**Application 3/2021/0275**

**Location: Land behind The Dog Inn, Market Place, Longridge PR3 3RR**

**Proposal: Proposed erection of 9 new dwellings and associated works**

**DIVERTED FOUL WATER SEWER LONG SECTION**

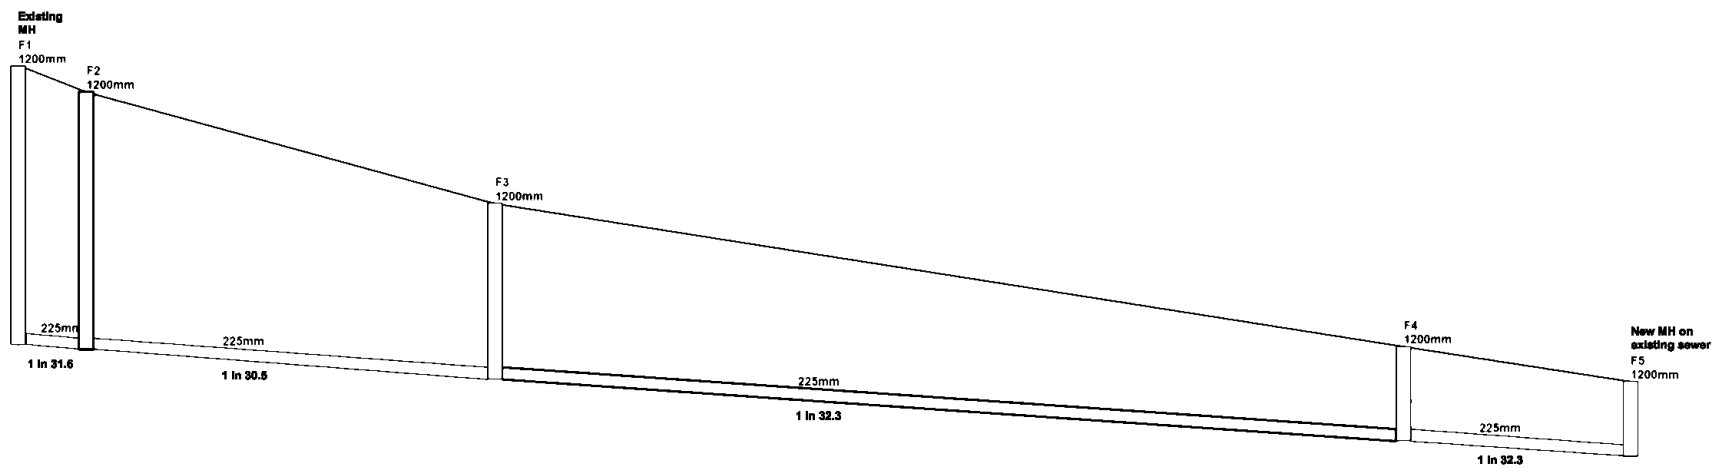
3. With regard to United Utilities previous comment regarding the proposed diversion of the public sewer within the site, development should not commence until the details of any diversion of the affected public sewer have been agreed and formally approved by United Utilities in writing. It is highly critical that the proposed diversion is assessed to understand whether any detriment that results in increased flooding potential is borne by the diversion. Therefore United Utilities would require a detailed drainage design including levels information and sewer long-sections to assess the impact of the diversion. A formal S185 diversion or design should be submitted for assessment as this may impact the proposed site layout. It is understood that the consultant wishes to agree this point by way of condition however the findings of the S185 sewer diversion assessment may result in alterations to the site layout. Without any manhole levels currently provided our previous response highlighted our concerns regarding a significant reduction in cover levels on existing manholes and the introduction of new bends.

In addition to the drainage drawing attached to this letter which includes the route of the proposed sewer diversion and level information, we also provide a long section along the proposed route of the 225mm diameter public sewer that is proposed to be diverted under a Section 185 agreement. A Section 185 application will be made on receipt of planning approval.
